Ducted Systems Technical Services: YS Letter

Letter:	YS-010-2022
Date:	November 21, 2022
To:	Ducted Systems (Factory Direct) S1 HVAC Branch Service, Sales, Warranty Managers
	Ducted Systems (Applied) Distribution Service, Sales, Warranty Managers
Subject:	Switching Relay Failures - 6HK Revision C Heat Kits
Product/s:	All 6HK revision C series residential heat kit accessories excluding 460V 3 phase
Effective:	November 21, 2022 Expires: November 21, 2024
Summary:	Labor and part allowance for replacement of a failed switching relay

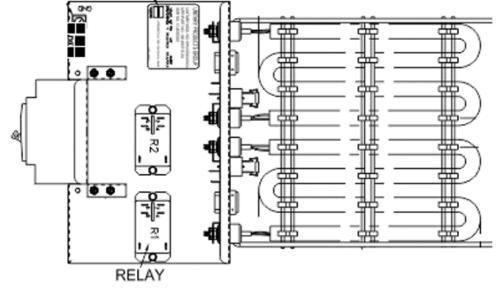
Source 1 and revision D heat kits are in stock. Note that you cannot order a heat kit based on revision letter as the revision letter is not viewable in the heat kit part number itself. The heat kit revision letter can only be seen on the carton label as shown to the right and the data plate affixed to the heat kit itself.
